service bulletin

M73-13
FAA-DER Approved

SUBJECT: Reaming and Bushing Rocker Shaft Bosses

MODELS AFFECTED: A65, A75, C75, C85, C90 O-200, O-300 and GO-300.

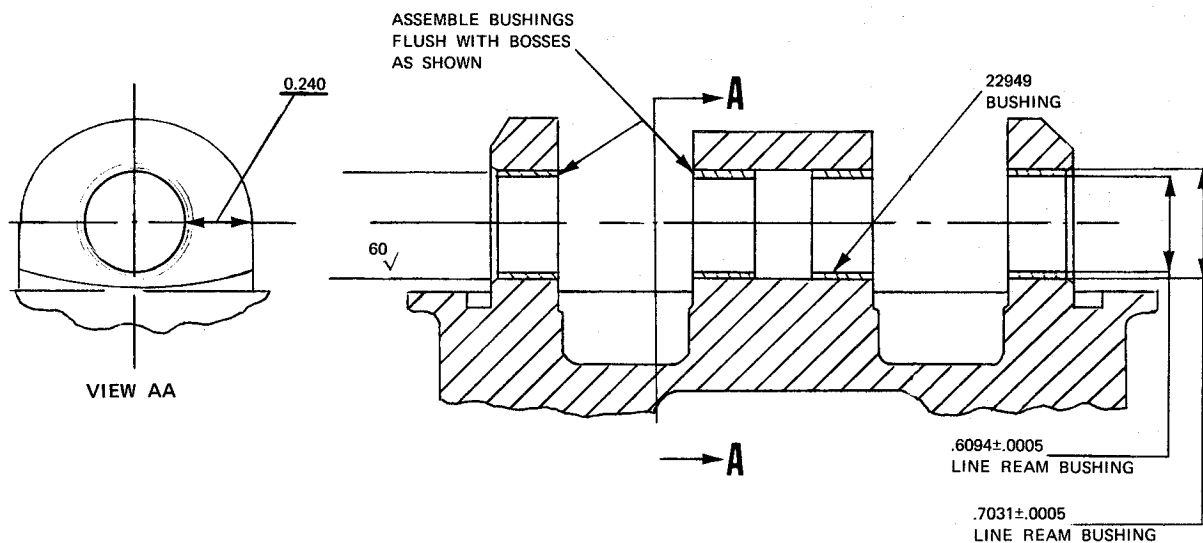
The following diagram is incorporated in our overhaul manual covering the subject engine models.

This method of repairing worn rocker shaft bosses on subject engine cylinder assemblies, is possible and recommended providing there is adequate stock in the wall at the center boss.

The following must be taken into consideration before proceeding with such repairs:

1. The minimum boss wall thickness measured at the edge of the center boss prior to any reaming and bushing must be .240 inch to be acceptable.
2. If the thickness of the center boss falls within this dimension, the bosses may be reamed. The center boss wall thickness must again be measured after reaming. If it is below .18 inch in any area, the cylinder must not be bushed and should be retired from service.
3. We cannot overstress the importance of producing a smooth finish on the inside diameter of the cylinder bosses when reaming prior to installation of the bushings. Too rough a surface bore finish can contribute to boss breakage. The bore surface roughness should not exceed 60 RMS.
